Technical product information

Topic	DTC B17B801 and/or B17B804 - evident within address 0019 and/or DTC U112300 evident in 00A5
Market area	Russische Föderation (5RU),Australia E04 Bentley rest Asia and Australia (6E04),China 796 VW Import Comp. Ltd (Vico), Beijing (6796),Germany E02 Bentley rest Europe (6E02),Japan E03 Bentley Japan (6E03),Korea, (South) E08 Bentley South Korea (6E08),United Arab Emirates E06 Bentley Middle East and Africa (6E06),United Kingdom E01 Bentley UK (6E01),United States E05 Bentley USA and rest America (6E05)
Brand	Bentley
Transaction No.	2063855/4
Level	EH
Status	Approval
Release date

Revision history

TPI 2063855/4 - Additional request to replace the control module (as Figure 1) in conjunction with the steering wheel

Figure 1

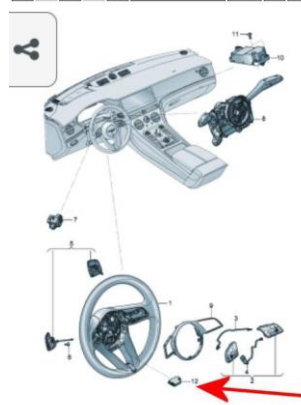
IMPORTANT: The operative must also replace the control module shown in Figure 1

2) Conduct a visual check between the original steering wheel and the replacement steering wheel to confirm all applicable components have been transferred successfully and control module replaced as shown in Figure 1

IMPORTANT: The operative must also replace the control module shown in Figure 1 - Refer to the ETKA parts catalogue
